Stinger Information Bulletin

Stinger Informational Bulletin 2024-2

Gateway Applicator Battery cover

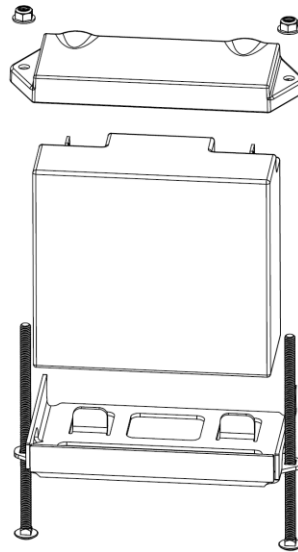
Summary: Improved battery cover was designed to replace the initial battery hold down.

Why: To reduce the possibility of fertilizer contamination and build up on the Gateway battery post(s), Stinger developed a custom fit battery cover (included) and hardware kit.

Recommendation: It is recommended to remove the existing battery hold down bracket and hardware. Clean the existing battery terminals. Make sure the battery cables are securely attached to the battery. Install the new battery cover using the provided hardware.

Kit Part Number: 95-4639
